Re: Country Village Lift Station and Forcemain Improvements
Aberdeen, South Dakota
Helms Project # A-10416

ADDENDUM NUMBER 1

AIR RELEASE MANHOLE DETAIL
NO SCALE

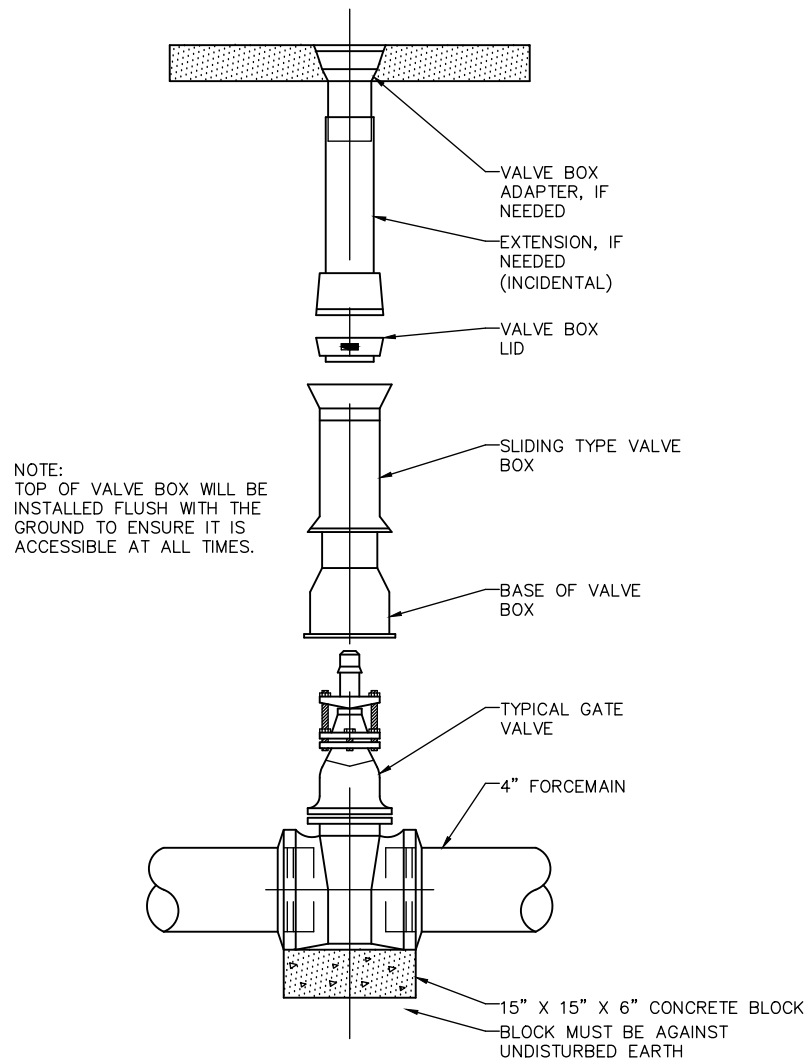
Sheet 22 shall be removed and replaced with the attached revised plan sheet. Revisions include: removal of the 1” valve size designation listed on the air release manhole detail and revisions to the manhole interior drop assembly detail. The interior drop structure shall utilize mechanical restrained joint fittings in lieu of the gasketed push on joints that were originally depicted. These revised details shall be utilized during both the bidding and construction phases of the project.
